**HISTORIC PRESERVATION REVIEW BOARD
STAFF REPORT AND RECOMMENDATION**

Landmark/District: **Walter Reed Army Medical Center Historic District** (x) Agenda
Address: **6900 Georgia Avenue NW**

Meeting Date: **August 3, 2017** (x) New construction
Case Number: **17-432**

Staff Reviewer: **Tim Dennée** (x) Concept

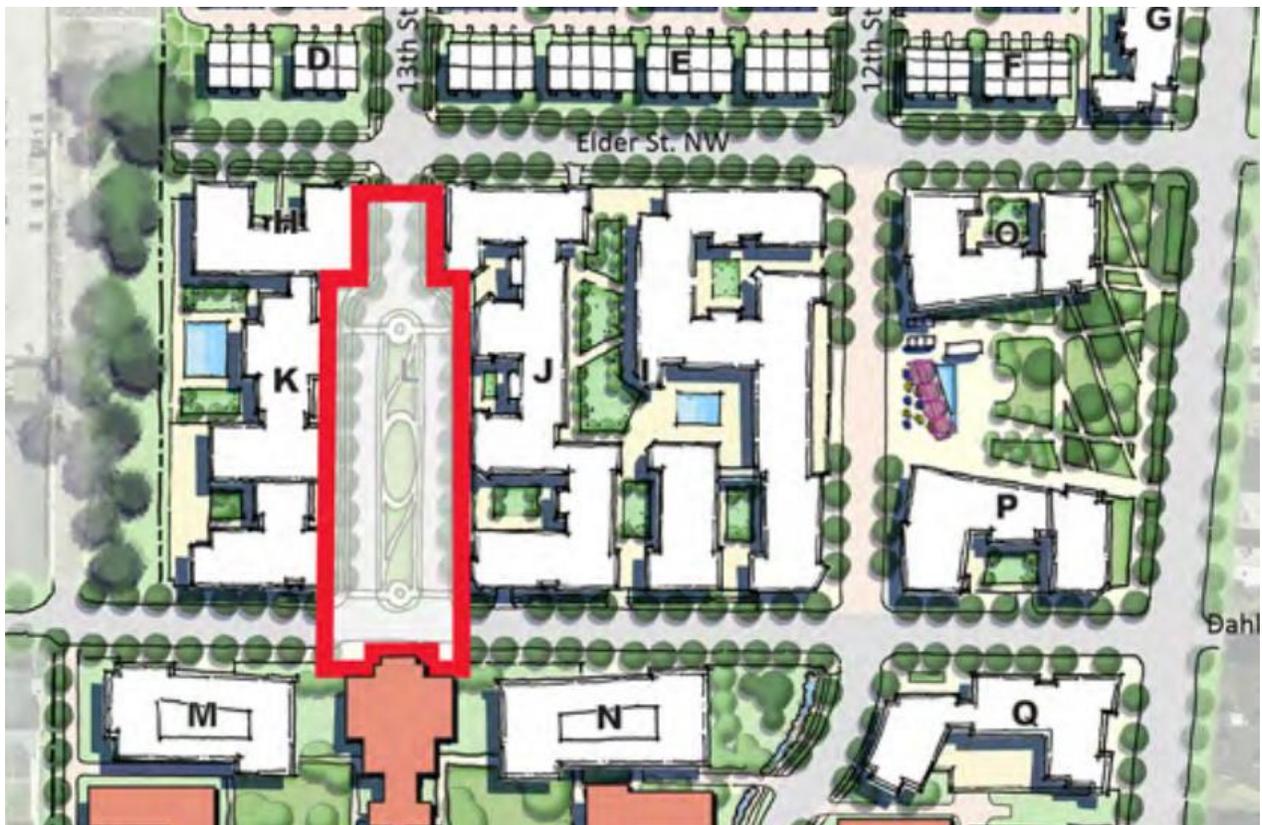
There is still ambiguity, even ambivalence, as to whether the building should read as one or as three. Despite their differences, the three sections have identical roof elevations, and each block is about the same width.

The one-building-as-three aspect of the proposal would be more effective if the design followed the direction that the center section of such a “long building” should be dominant. Some change in parapet height and the widening of the central section relative to the others could help make the center more dominant. That sort of hierarchy need not reinforce the overall symmetry of the composition (although, it could do so, if desired), but it could help the north and south wings read as secondary to the center. The widening of the center would effectively narrow the front elevations of the north and south wings, each of which is too nearly equal the dimensions of the side elevations. Each wing of the building could use more of a sense of independence and a hierarchy among its own parts.

The central section of the building has a similar issue, in that its center pavilion has about the same width as each of the flanking masonry walls, a condition that is emphasized by the static four-bay arrangement of the punched openings in those walls.

This central pavilion, a bold gesture, is nonetheless a relatively weak one and not very compatible with the character of the historic district. The scale-less glass piece projects, yet it contributes to a feeling of void at the center of the composition with its flatness and translucency. It may read as a light box at night, not necessarily a desirable feature, but could also look odd when only partly lit from within. The storefront below the projection is recessed, not only

relative to the projection, but to the primary wall plane, a condition that has not generally been optimal for retailers. This void is coupled with another at the uppermost story, another recess albeit capped with a large canopy.

The southern wing, with its recessed top floor, takes a step toward deferring to the center of the building, but that gesture is counteracted by a monumental, corner-frame element that competes with the center and suggests that the whole is a corner-focused and not center-focused building. This frame also seems to divide, rather than unite, this south “building,” neither connecting the two street elevations to each other or to the storefront below. It seems calculated largely as a visual landmark marking the corner retail space. It is neither a “glass corner,” nor a “proportionally minor element.”

Projecting balconies (as opposed to porches, where appropriate) should be minimized in number and extent in any historic district not characterized by them. The design guidelines do not say much about balconies. Regarding existing buildings, but also as a guide to new ones, the guidelines state that “Porches and balconies are an integral part of the building composition and, when present, are a significant architectural element....” The campus examples pictured are not really balconies at all, but rather double-height porches, projecting or recessed, and in each case, the terrace area is enveloped by structure. The southern wing does a better job of incorporating the balconies into the mass of the building, but the balcony voids have become the principal detail of the elevations. The north wing, on the other hand, unfortunately projects the balconies and their supporting tie rods.

HPO recommends that the Board support the concept in terms of height and footprint, with revisions to be made to the elevations shown, and information added for the elevations not yet drawn. The design should express less ambiguity about whether the wings should be seen as part of the whole or as distinct buildings.
